**IN THE OFFICE OF PUBLIC ACCOUNTABILITY
 PROCUREMENT APPEAL**

| IN THE APPEAL OF: |) | DOCKET NO. OPA-PA-17-010 |
| And |) | EXHIBIT LIST |

**ROUTE 1/ROUTE 8 INTERSECTION IMPROVEMENTS
AND AGANA BRIGES REPLACEMENT
PROJECT NO. GU-NH-0001(014) and PROJECT NO. GU-DAR-0001(014)
(DESIGN-BUILD)**

TYPICAL DRIVEWAY
AS INSTALLED BY CTT.
N.T.S.

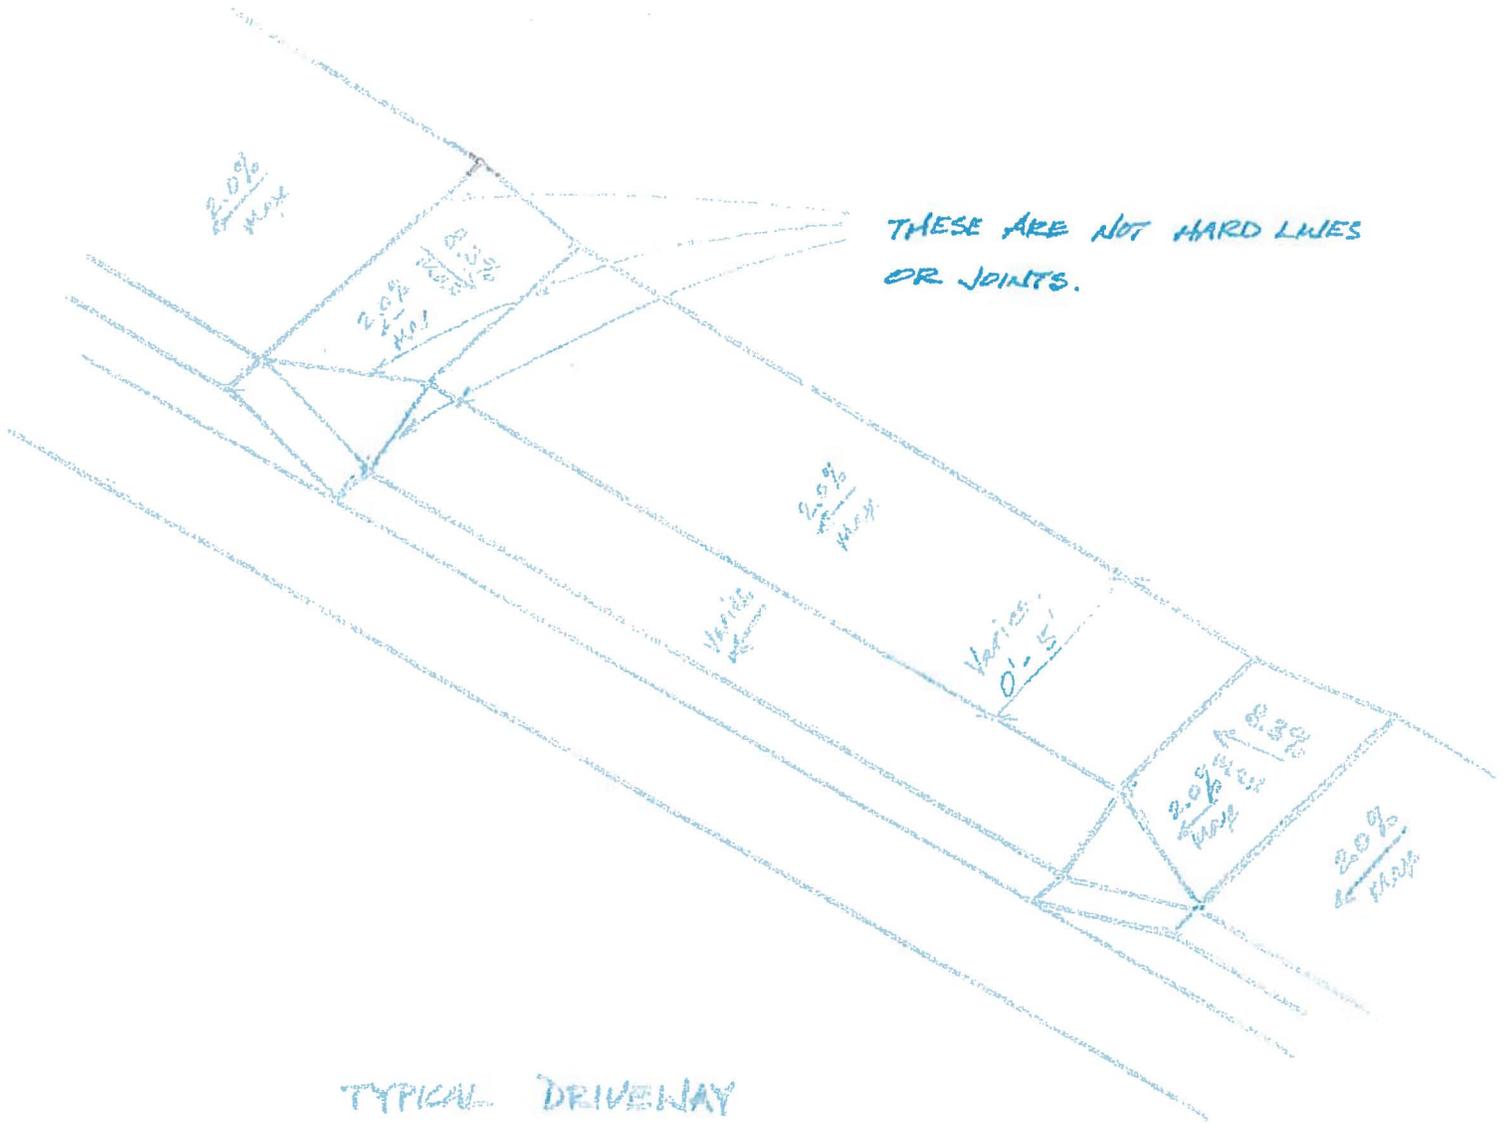
Sheet C-17 of the Conceptual Drawings detailed a typical driveway cross-section that is in compliance with the American with Disabilities Act (ADA). CTI provided an alternate design for the driveway shown on Detail B/Sheet PLN-5 of the Approved Civil Drawings.

CTI must survey and correct the driveways installed on Routes 1 and 8 that are non-compliant. CTI shall coordinate with the Designer of Record to develop a corrective procedure or replacement.
